UNITED STATES PATENT AND TRADEMARK OFFICE

APPLICATION NO.	FILING DATE	FIRST NAMED INVENTOR	ATTORNEY DOCKET NO.	CONFIRMATION NO.
09/992,092	11/05/2001	James H. Bucksbee	IR-2860(MT)	9463

Office Action Summary

DETAILED ACTION

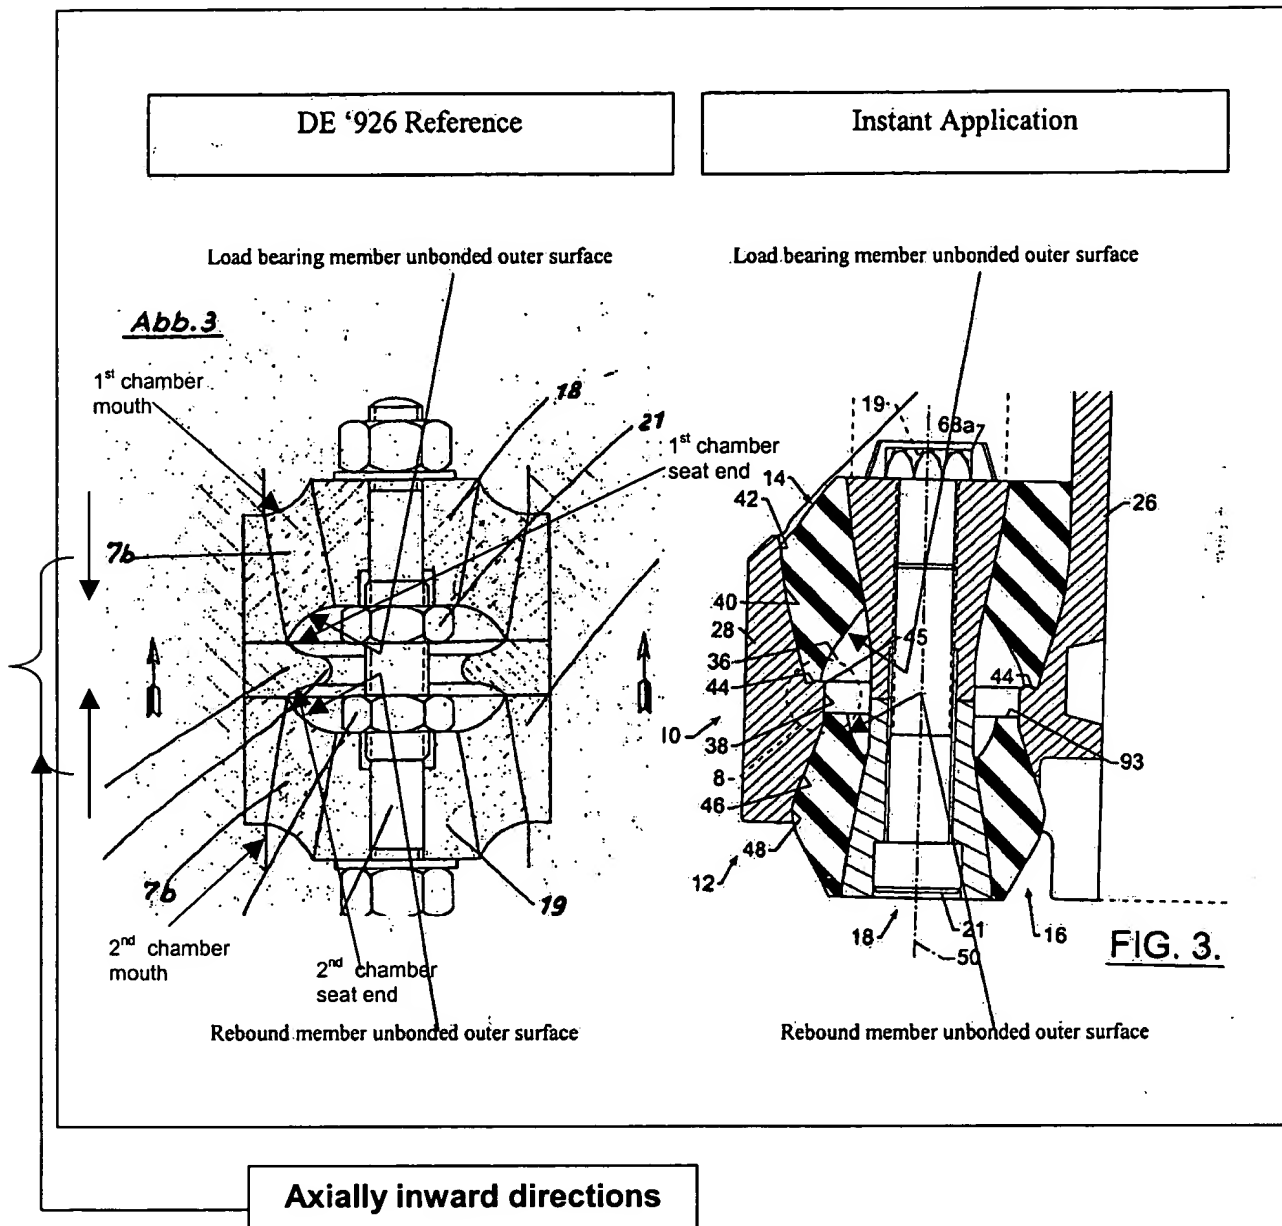
Re: claims 1, 4, 6, 11, 12, 15, 17, 22, 23, 25, and 26. DE '926 shows in figure 3 a mount comprising a rigid housing, the housing having a hollow barrel with a central axis and a first end and an opposing second end, the hollow barrel shown in the area of element 17 defining a first chamber in which upper element 7b is located proximate the hollow barrel first end, a second chamber in which lower element 7b is located proximate the hollow barrel second end, and a seat opening communicating between the first chamber and the second chamber, the seat opening between the hollow barrel

Re: claim 24. DE '926 shows in figure 3 the limitation wherein the load bearing member comprises a plurality of alignment members or nut and washer shown above element 18 along the support surface.

Re: claim 21. DE '926 show in figure 3 the limitation wherein the mount further comprises a plurality of arms or left and right projections shown in the area of element 24, the arms extend between the mount base and the barrel as shown.

Applicant argues that the unbonded outer surfaces of DE '926 are outwardly tapered in the direction of the mouth to the seat end. Examiner disagrees. As shown in figure 3 of the DE '926 reference labeled above the load bearing member outer resilient member unbonded outer surface is axially inwardly tapered in a direction from the first chamber mouth to the first chamber seat end. Similarly, the rebound member outer resilient member unbonded outer surface is axially inwardly tapered in a direction from the second chamber mouth to the second chamber seat. Examiner has labeled the axially inward directions on page 9 and notes that the claim language does not preclude the inward direction from meaning an axial inward direction. Accordingly, the rejections have been maintained.
